Submission in relation to SSD-86017721 – Residential Development with In-fill Affordable Housing at 23- 31 Dover Road, Rose Bay

Our client, Pathways, owns 20- 30 Wilberforce Avenue and 33- 37 Dover Road, Rose Bay which directly adjoins 23- 31 Dover Road, Rose Bay (to the south) to which SSD-86017721 relates. Our client has requested we review the documentation submitted to the Department for Planning, Housing and Infrastructure (DPHI) for SSD-86017721.

Figure 1 Extract of Ground Floor, non-compliance highlighted in red (Source: Architectural Plans - SSD-86017721)

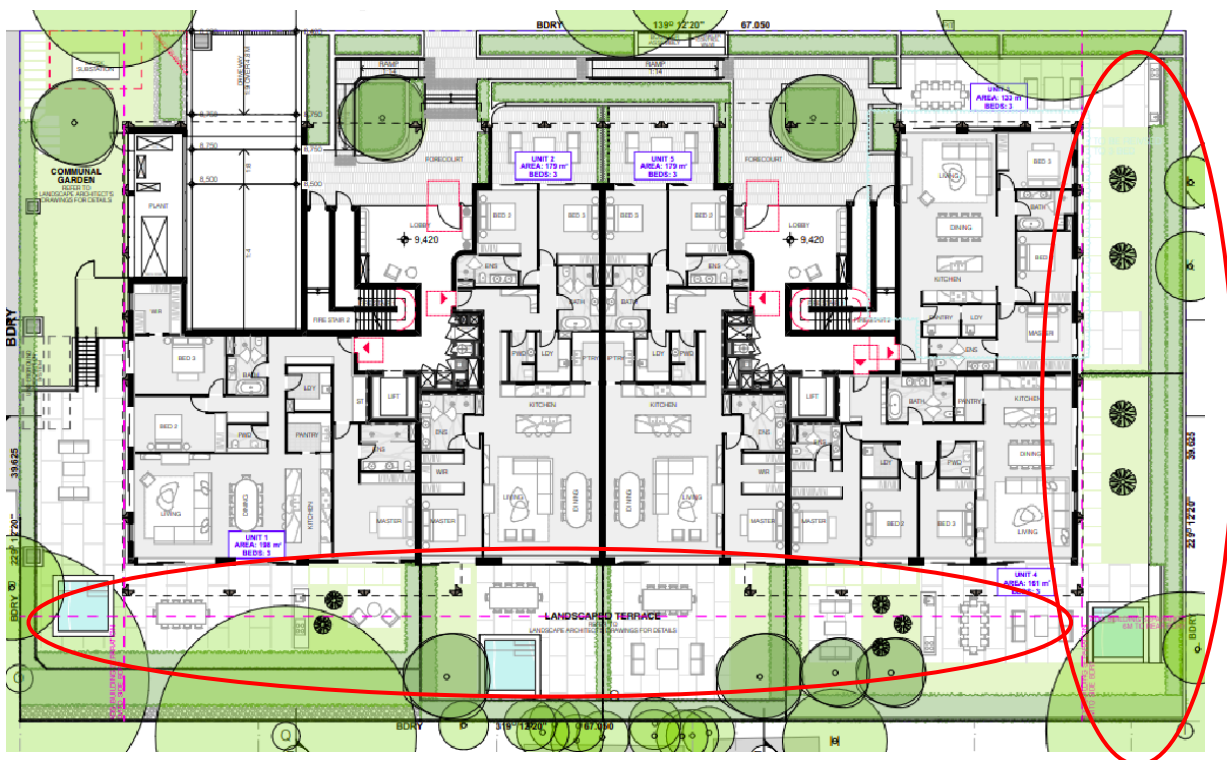
- The ground floor terraces encroach within the 6m building separation distances to the rear and side boundaries, including the south and east elevations adjoining our clients site, indicated by a pink dotted line in Figure 1. Side and rear setbacks should provide adequate visual and acoustic privacy between neighbouring properties. Whilst we understand that planting screening is proposed, the ground floor comprises a plunge pool less than 3m from the south-east boundary (shared with our client's site) raising both visual and acoustic privacy concerns given the close proximity to the shared boundary. We would welcome more detail on the proposed ground floor screening to better understand the privacy mitigation measures in place.

Figure 2 Extract of Level 5 Plan, non-compliance highlighted in red (Source: Architectural Plans - SSD-86017721)

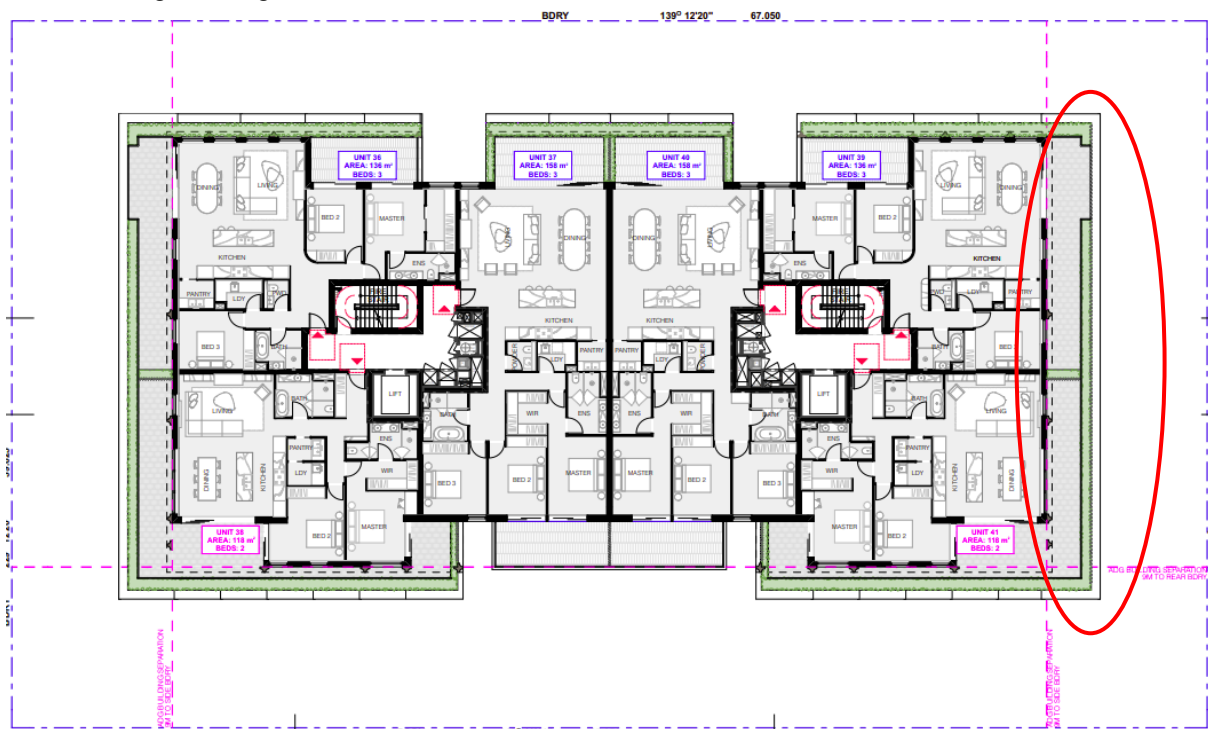
- Level 5 encroaches into the required 9m side and rear setbacks, indicated by a pink dotted line in Figure 2. The ADG requirement for additional separation above 4-storeys seeks to minimise overlooking into neighbouring properties for visual privacy reasons but also reduce the overall bulk and scale of the building. The balconies encroaching within the 9m setback with the shared boundary therefore create visual privacy and overlooking concerns, and result in a bulk and scale building that is not compatible with neighbouring sites.

Figure 3 Extract of Shadow Diagram 3pm (Source: Design Report - SSD-86017721)

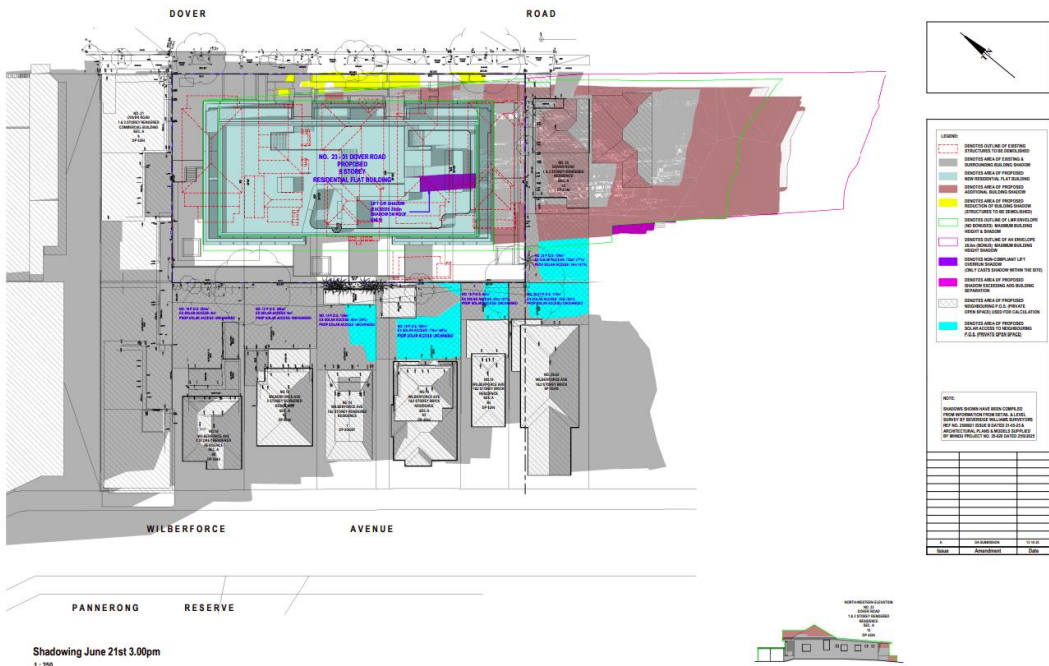
For example, at 3pm midwinter, additional shadow is cast on the rear of 35 Dover Road. This is shown in dark pink in Figure 3 which highlights area of shadow resulting from ‘*exceeding ADG building separation distances*’. We therefore request that the side and rear separation distances are achieved to ensure minimum separation distance requirements of the ADG are complied with to ensure the overshadowing impacts are minimised as far as possible.
